**Environmental
Protection Agency**

August 24, 2010

RE: BROOKSIDE AUTO PARTS INC
3GR00210*DG
INDUSTRIAL STORMWATER
CUYAHOGA COUNTY

Figure 1: Car processing concrete pad. The oil residue is noticeable, the pad should be replaced and containment (i.e. containment dike) be installed.

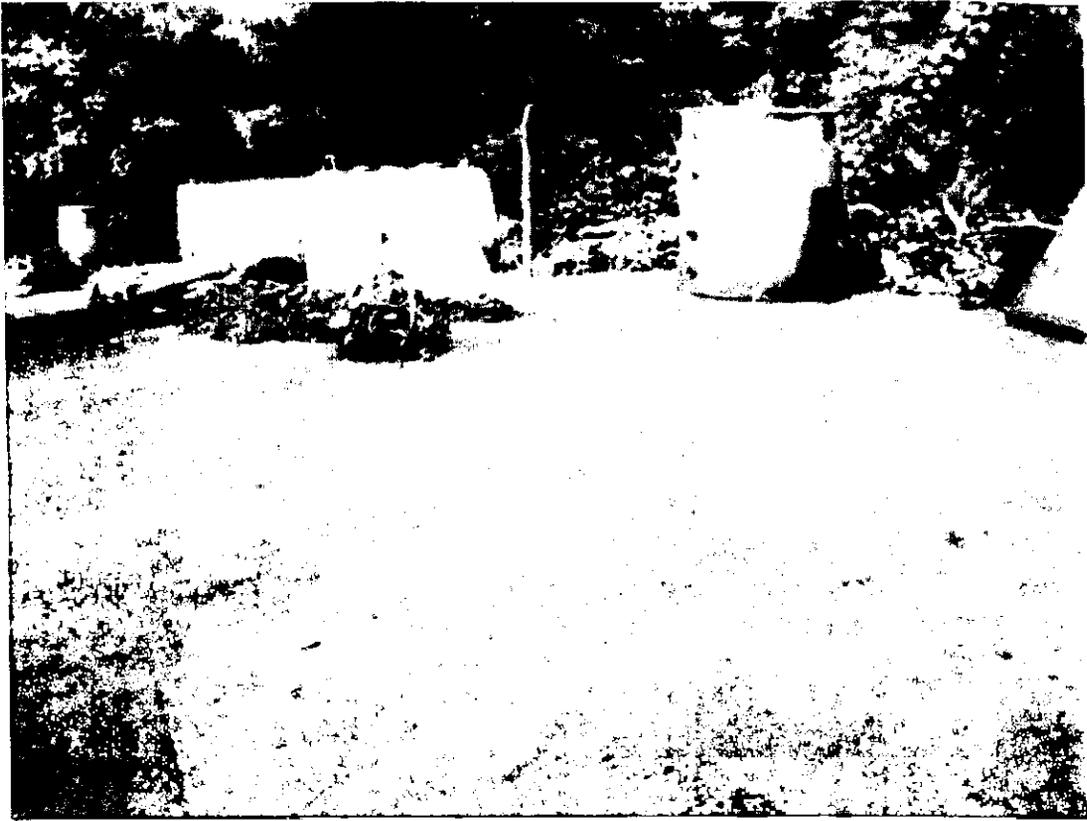
Figure 2: Oil container on the car processing pad. This tank has secondary containment but needs to be labeled "Used Oil".

Figure 6: Oil water separator. There is a lot of floating debris in the water; the oil water separator should be kept clean to eliminate any possible clogs or discharges of pollutants.

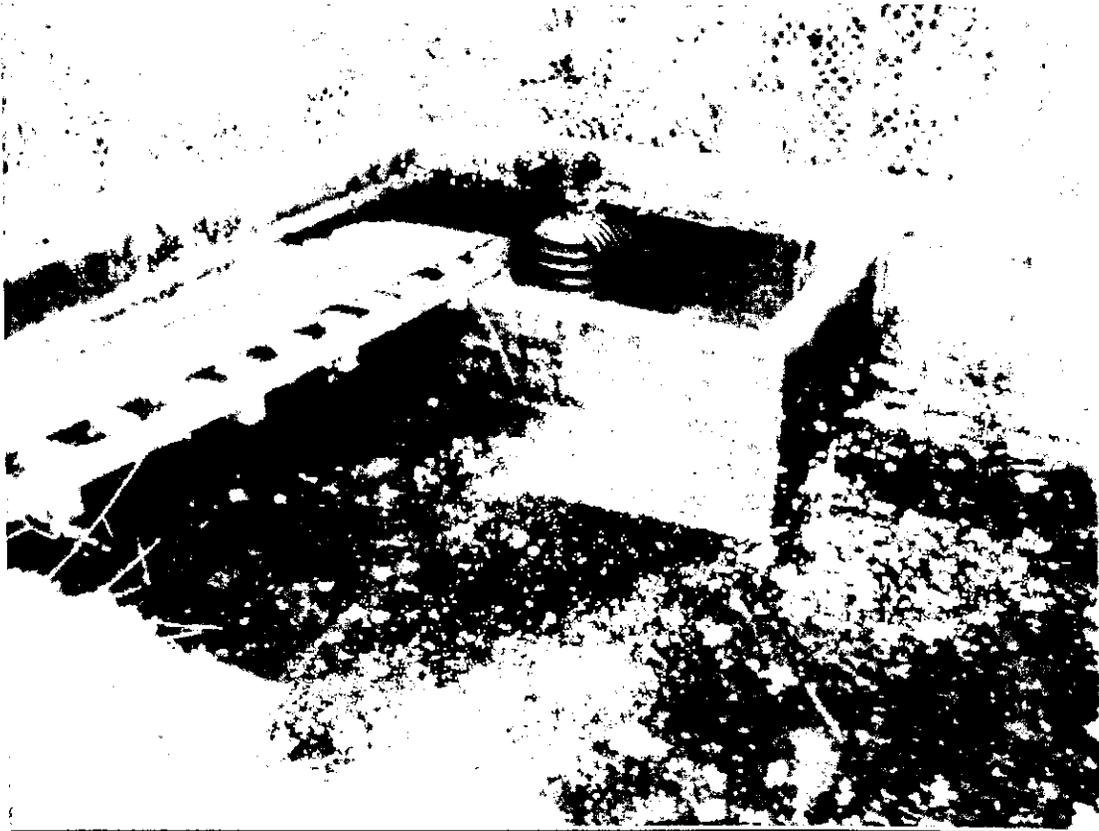
Figure 8: Outfall of the oil water separator. This area should be kept clear of any debris.
